SUBJECT: ISSUANCE OF AMENDMENT NO. 58 TO FACILITY OPERATING LICENSE NPF-9 AND
AMENDMENT NO. 39 TO FACILITY OPERATING LICENSE NPF-17 - MCGUIRE
NUCLEAR STATION, UNITS 1 AND 2

DUKE POWER COMPANY
DOCKET NO. 50-369
MCGUIRE NUCLEAR STATION, UNIT 1
AMENDMENT TO FACILITY OPERATING LICENSE

SAFETY EVALUATION BY THE OFFICE OF NUCLEAR REACTOR REGULATION
RELATED TO AMENDMENT NO. 58 TO FACILITY OPERATING LICENSE NPF-9
AND AMENDMENT NO. 39 TO FACILITY OPERATING LICENSE NPF-17

FIGURE 5.1-4

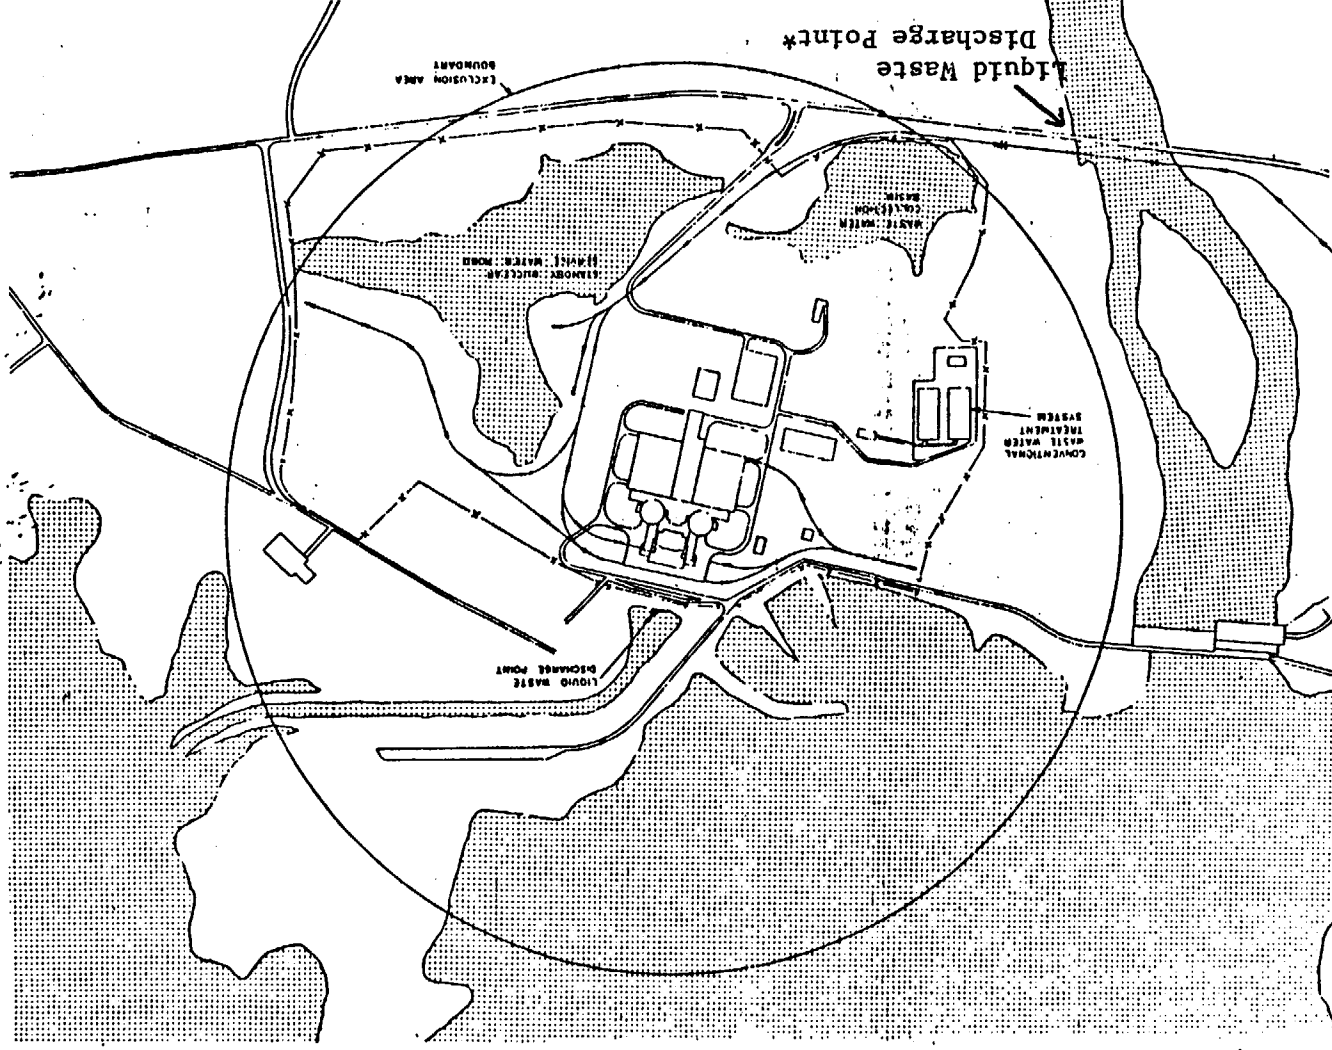
The amendments change Figure 5.1-4 of the Technical Specifications to permit a one-time discharge to the Catawba River of wastewater from the Conventional Wastewater Basin containing very low concentrations of tritium. The amendments are effective as of the dates of issuance.

*This discharge point is authorized for a one-time discharge of water from the Conventional Wastewater Basin which contains trace amounts of tritium in addition to the normally processed effluents of the Waste Water Collection Basin, effective June 20, 1986.

These amendments authorize a one-time release of the existing contents of the Conventional (non-radioactive) Wastewater Basin, containing trace amounts of tritium, into the Catawba River. Technical Specification (TS) 3.11.1.1 and its referenced Figure 5.1-4, "Site Boundary for Liquid Effluents" define the authorized discharge point for radioactive material released in liquid effluents to unrestricted areas as being only to Lake Norman. The authorization is accomplished by the addition of a footnote to TS Figure 5.1-4 at the discharge point for the Conventional Wastewater Basin into the Catawba River, stating that this discharge point is authorized for a one-time discharge of water which contains trace amounts of tritium in addition to the normally processed effluents of the Waste Water Collection Basin, effective the date of Commission approval. The change does not affect any existing limits or procedures regarding the processing of conventional (i.e., non-radioactive) contaminants. These revisions to the technical specifications are made in response to the licensee's application for amendments dated May 20, 1986.

By letter dated May 20, 1986, the licensee noted that tritium, but no other radionuclide, had entered the Basin and had subsequently been diluted to a concentration of 1.4×10^{-5} microcuries per milliliter. The licensee proposed to discharge the 4 million gallons of water in the Basin, along with its tritium, to the river at a rate of 500 gpm over a duration of 133 hours. The Basin discharge would also be mixed by at least equal flow from the Standby Nuclear Service Water Pond, such that the tritium concentration at the river release point would be no more than 7×10^{-6} microcuries per milliliter. This

concentration is well within the limit of 3×10^{-3} microcuries per milliliter specified by 10 CFR 20.106 and associated Appendix B, Table II, for tritium concentrations in water released to an unrestricted area. The total amount of tritium to be released (about 0.25 curies) is small compared to the normal release of tritium from the plant (about 2.5 curies per day).
